Summary of response to IRR concern about the FXI mirror hard-stop

Location of 'stop blocks'.

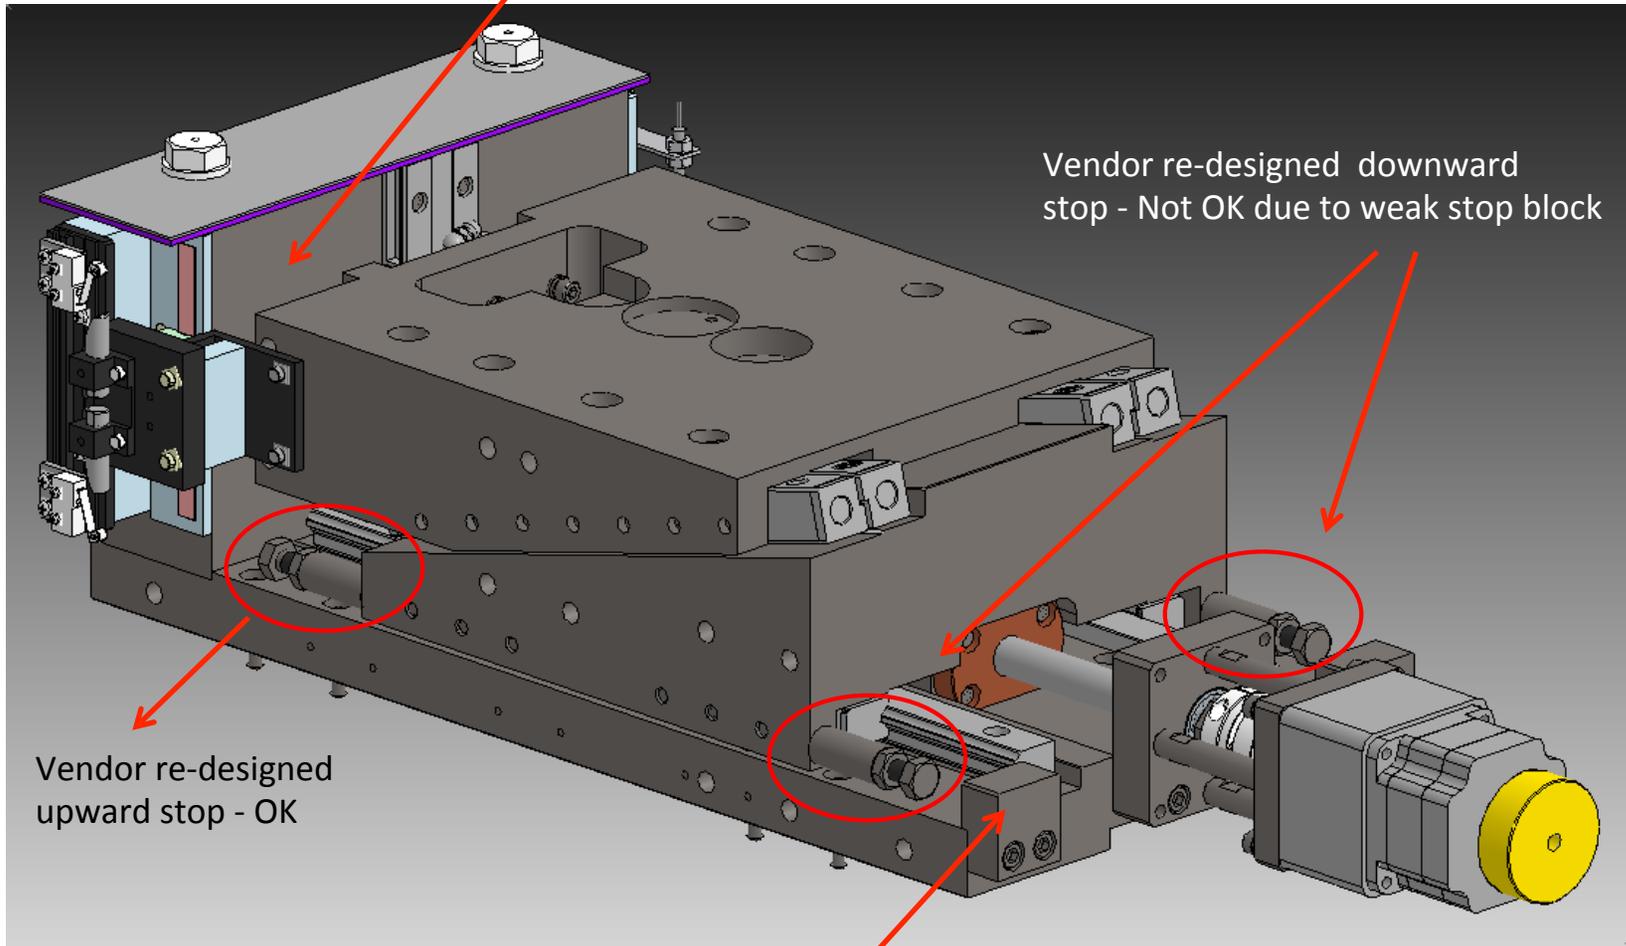
1. Vendor re-designed hard-stop. NSLSII design review of this was held on Nov 7. Reviewers did not think it will work for the 'downward' side of the stage. The problem is that at the 'downward' limit of the stage, the stop block is held by two M6 screws in tension, which FEA shows is insufficient to resist the maximum force. Made suggestions for alternative solutions. (see next page and *FXI_Hardstop_DesignReview_Nov7 & PS-DRR-1064 – Collimating Mirror Hardstop PDR*)

Upward side stop block- held by eight M8 screws in shear from below

Vendor re-designed downward stop - Not OK due to weak stop block

Vendor re-designed upward stop - OK

Downward side stop block – held by two M6 screws in tension

2. Engineer Bernie Kosciuk came up with a new idea. Held a design review for his new idea on Dec 6. Review panel approved Bernie's design for the 'downward' limit and the vendor design for the 'upward' limit. The reason that the vendor design is approved for the 'upward' limit is because there, unlike the 'downward' side, the stage has a stop block that is held by eight M8 screws in shear that can easily withstand the maximum force. (see next page and *FXI_Hardstop_DesignReview_Dec6 & PS-DRR-1065 – Collimating Mirror Hardstop FDR*)
